Access Compliance Report

Public Rights-of-Way

Intersection ID: 9578	Main Street: WOODWARD_AV	Cross Street: STATESVILLE_AV	Location: NW
ADA ID: 6AACC8827C8C	Ramp Type: Perp	Initial Pass/Fail: Fail	Overall Compliance: No
			Severity Score: 21.25

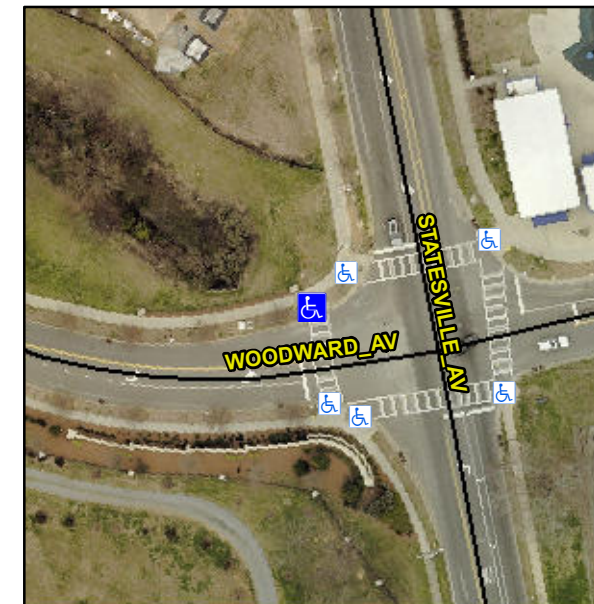
Not Found, R304.5.1, R304.2.2

Compliance	Description	Data	Compliance	Description	Data
N/A	Ramp Length (in)	96.5	No	Ramp Slope (%)	9.2
No	Ramp Width (in)	45.0	Yes	Ramp XSlope (%)	1.0
N/A	Flare Type LT	N/A	N/A	Flare Type RT	N/A
N/A	Flare Slope LT (%)	N/A	N/A	Flare Slope RT (%)	N/A
N/A	Flare Traversable LT?	N/A	N/A	Flare Traversable RT?	N/A
N/A	Landing Length (in)	N/A	N/A	DWS Provided?	N/A
N/A	Landing Width (in)	N/A	N/A	DWS Contrast?	N/A
N/A	Landing Slope (%)	N/A	N/A	DWS Length (in)	N/A
N/A	Landing X Slope (%)	N/A	N/A	DWS Full Width?	N/A
N/A	Landing Curb? (Y/N)	N/A	N/A	DWS Offset (in)	N/A
N/A	Shared Landing?	N/A			
N/A	Gutter Ponding?	N/A	N/A	Gutter Slope (%)	N/A
N/A	Gutter Lip Ht (in)	N/A	N/A	Gutter X Slope (%)	N/A
N/A	Painted X Walk1?	No	N/A	Painted X Walk2?	N/A
	X Walk 1 Direction	To S		X Walk 2 Direction	N/A
N/A	X Walk 1 Width (in)	N/A	N/A	X Walk 2 Width (in)	N/A
	X Walk 1 Slope (%)	2.4		X Walk 2 Slope (%)	N/A
	X Walk 1 X Slope (%)	2.2		X Walk 2 X Slope (%)	N/A

Remove & Replace Entire Ramp.
